Subject: Collin County Healthcare Facility, Parking Garage, and Medical Examiners
PCO No. 051; RFI #174 PG Cast Stone Detail 4/PG-A0.40

Issue No. 051 - RFI #174 PG Cast Stone Detail 4/PG-A0.40

RFI#174 - WIDENED BEAMS AT PARKING GARAGE WEST START ROOF FOR CAST STONE COORDINATION

RFI #174: PG - Cast Stone at 2nd Floor Parking Garage Storefront

ELEVATION VIEW 4

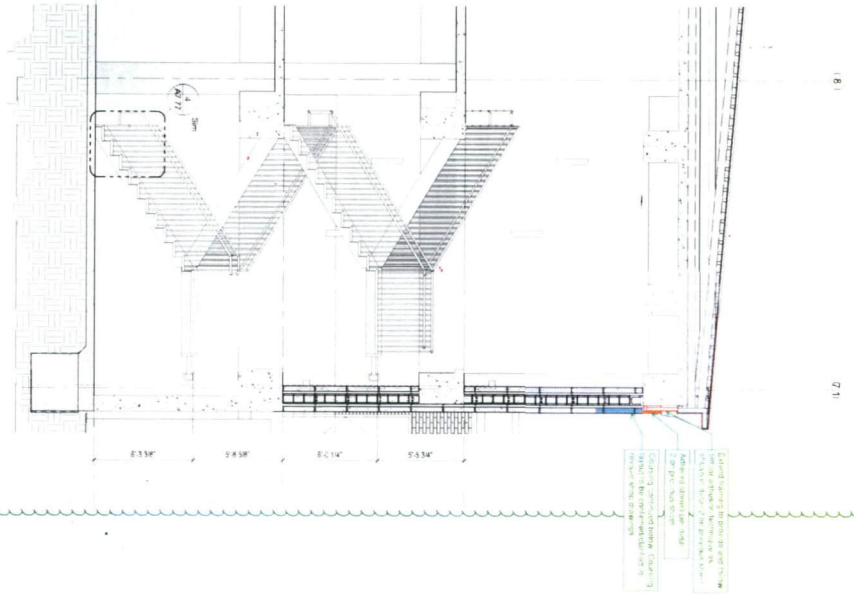
Option 3: (From existing) stone provided and supported by steel wall after adding steel bracing system. (Should include bracing considerations for existing masonry support for steel bracing wall. Must include details for bracing to be added to wall to transfer load to wall.)
